Document Update Notification

DOCUMENT NO: OP-1903.068

TITLE: EMERGENCY RESPONSE FACILITY-
EMERGENCY NEWS CENTER ENC

CHANGE NO: 006-00-0

EMERGENCY OPERATIONS FACILITY (LOWER FLOOR)
EMERGENCY NEWS CENTER AND MEDIA AREAS

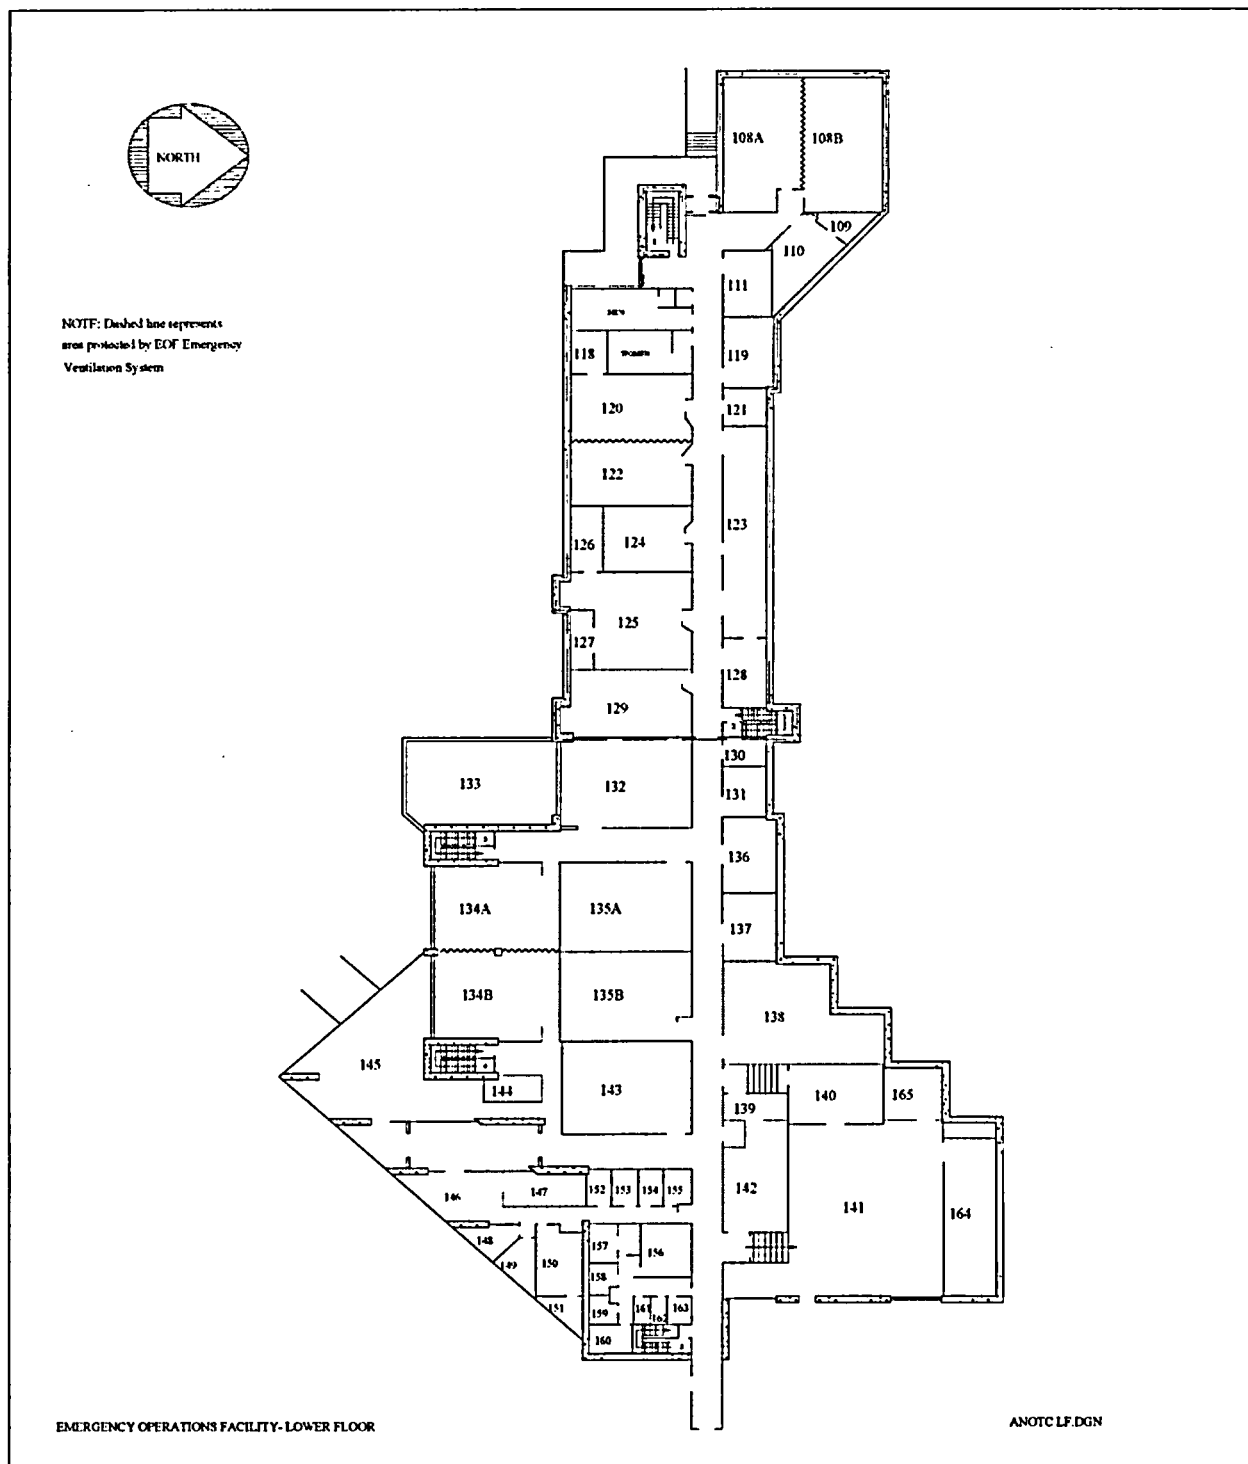
Attachment 5
(Room Assignments)
Page 30

Removed room 144 from list

EMERGENCY NEWS CENTER (ROOM 240)

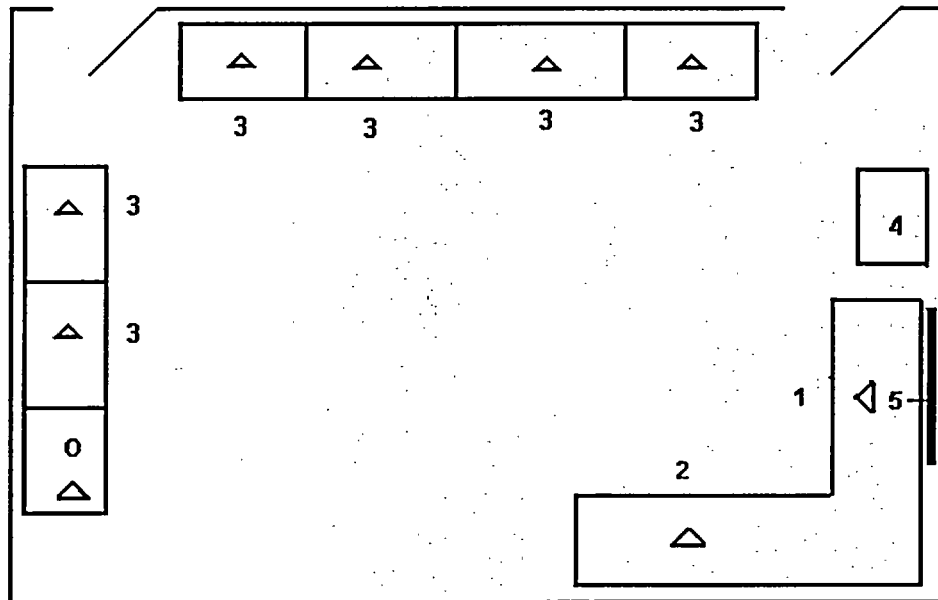
Attachment 7
(ENC Room Map)
Page 33

Revised room map for room 240 (ENC) to reflect current arrangement and equipment
